# WATER EFFICIENCY AND SANITATION STANDARD (WE-STAND) TECHNICAL COMMITTEE MEETING IAPMO WORLD HEADQUARTERS,

**APRIL 5 – 6, 2016**

## WEStand TENTATIVE ORDER OF DISCUSSION Proposed Changes to the 2017 WE-Stand

## 2. Valves for flushing crossover lines

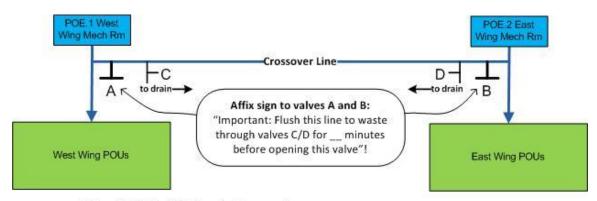
Although lines connecting one domestic water system to another (crossover lines) can be beneficial in allowing either system to supply the other when one is down for maintenance, the water in crossover lines becomes stagnant if the design does not allow enough flow through it. This presents two problems: First, during normal use of the system, stagnant water in the crossover line can be drawn into the domestic water system whenever pressure changes occur. Second, when the crossover line is opened to feed one system from the other, potentially contaminated water that has been sitting in it for weeks or months gets distributed to faucets and other fixtures.

To allow a crossover line to be isolated and flushed to waste periodically and before each use, shut-off valves should be installed at each end, instead of just one shut-off valve on the line, with another valve on a line piped to a drain just downstream of the shut-off valves.
